Philips Image Guided Therapy Corporation  
**URGENT Field Safety Notice**  
Philips Laser System (LAS-100) Error 500

JUN-2022

Reference: LAS-100 Error 500, 2022-IGT-IGTD-002

*Figure 1: Example of an Error 500 visual alert*

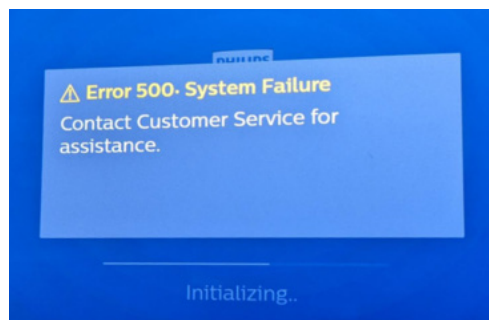
Philips has identified an intermittent mechanical fault with the LAS-100 Philips Laser Systems manufactured prior to 18-MAY-2022. For affected units, on occasion, the system may detect an inoperable hardware component during power up. When this issue occurs, the user will be visually alerted on the system display as “Error 500 – System Failure” (see Figure 1). The user will not be able to proceed until the error is cleared. In this event, a delay in treatment may occur since the device is not able to fully initialize to a ready state. This fault was identified after seven (7) complaints of Error 500 were received. To date, Philips has not received reports of patient or user harm due to this issue.

Philips internal testing confirms that 1-3 reboots of the system will temporarily resolve the issue. Philips also recommends the continued use of the Philips Laser System, and to follow the Operator's Manual, as there is no expected harm to the user or patient.

Philips will notify all affected customers and arrange for a Field Service Engineer (FSE) to replace the shutter assembly with an improved shutter assembly free of charge beginning June 2022,. The updated assembly improves the Philips Laser System's performance and integrity.
